TO: Diamond Schmitt Architects and KWC Architects
FROM: WSP Canada Inc.
SUBJECT: Revised Supplementary comments to the final geotechnical report Rev. 2
DATE: July 21, 2020

In the comments from the site Site Plan Application Plan (City of Ottawa File Number: D07-12-19-0205) it was requested that WSP Canada Inc. (WSP) geotechnical provide updates to the geotechnical report. The following sections are to complete the geotechnical report, dated December 2019.

CARLETON UNIVERSITY NEW STUDENT RESIDENCE

S200

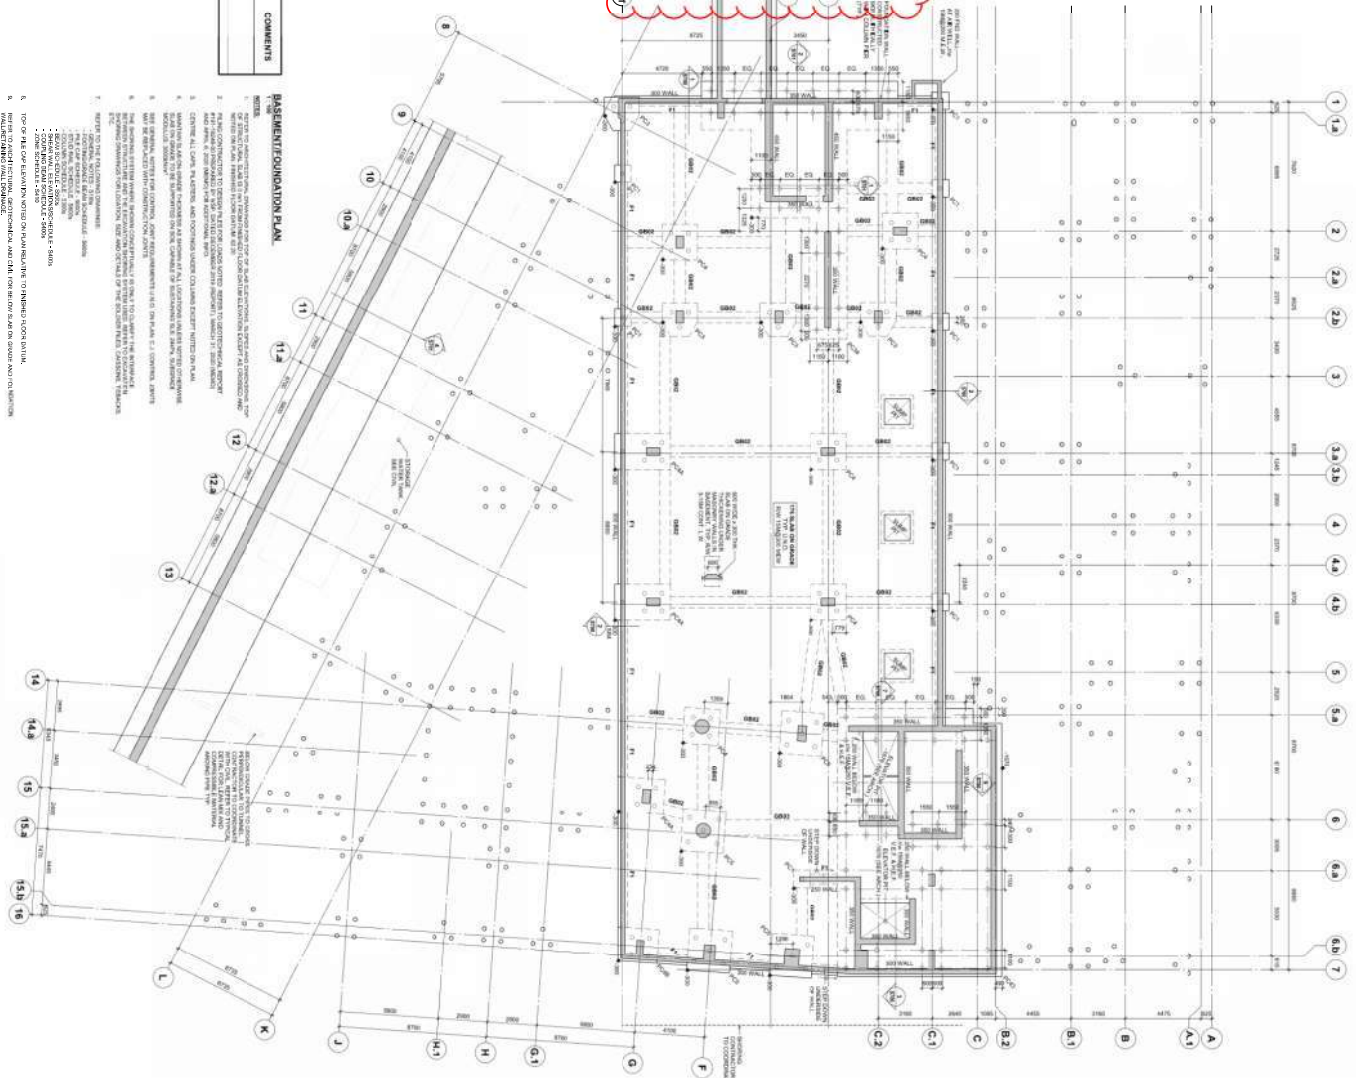
WSP was provided with the plans by Read Jones Christoffersen Ltd (RJC) entitled CU NSR Foundation Permit Structural-S200 and CU NSR Foundation Permit Structural-S701 both dated April 7th, 2020 in order to review the design of the proposed tunnel from a geotechnical perspective. These documents have been included with this design memo. Within document S200 it outlines that the design requirements for the tunnel slab as well as the providing instruction to refer to general notes and typical details for tunnel geotechnical requirements and well as to coordinate with the geotechnical consultant (WSP). Based on the proposed details, the tunnel foundation will be approximately 5.85 m below the existing ground surface. The geotechnical investigation carried out in 2019 did not have boreholes along the proposed alignment of the tunnel, but based on the general soils information within the building footprint, the USL and SLS values for a tunnel foundation placed on either the sand and gravel deposit or the glacial till deposit can be taken to be 200 kPa and 100 kPa respectively. Prior to the placement of the tunnel foundation the bearing soil will have to be inspected by a qualified geotechnical engineer and this assumption be verified. It should be understood by any contractor taking on the excavation of the tunnel foundation that localized area along the proposed alignment may not be suitable and require over excavation. These areas will be placed with an approved granular fill compacted to 100% of the materials standard proctor maximum dry density (SPMDD) value.

CASING CROSS SECTION

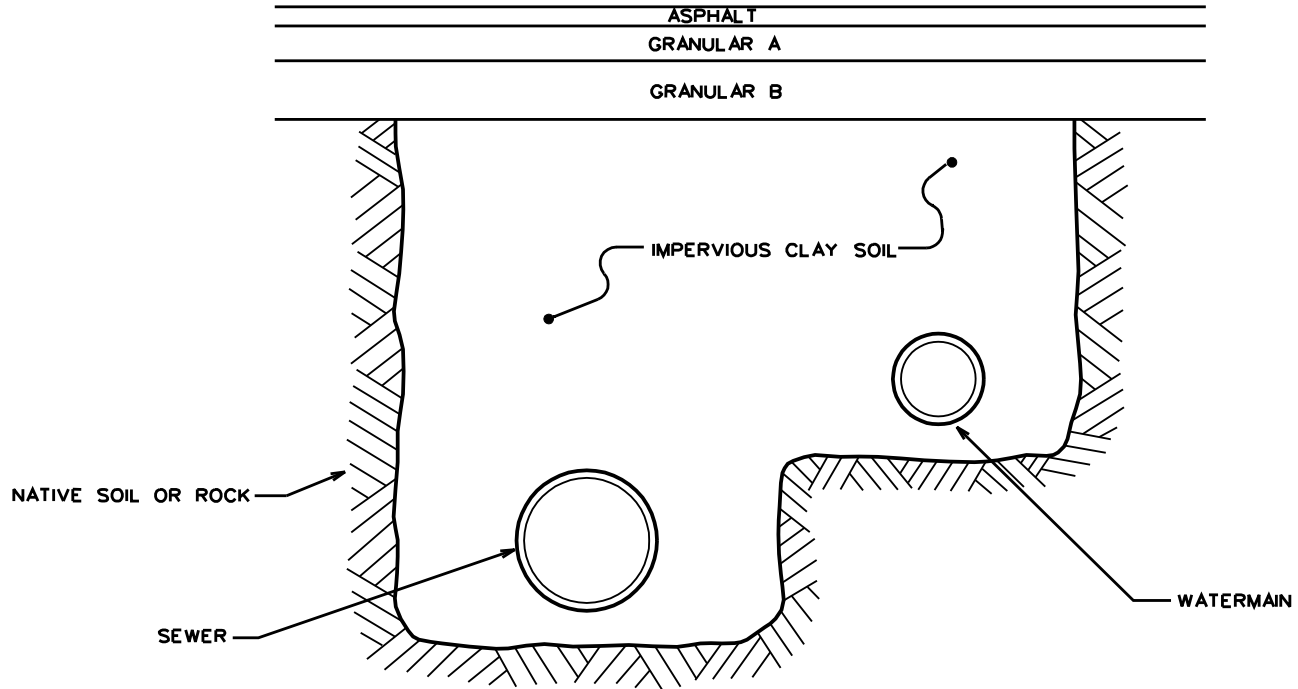
Regarding the galvanized steel casing, the document 190444600_CU NSR Casing Detail_11May2020 was provided to WSP and is included with this memo. From a geotechnical perspective, a minimum clearance of 300 mm of cover is required for all pipe installations and the inclusion of a steel casing needs to take this in consideration.
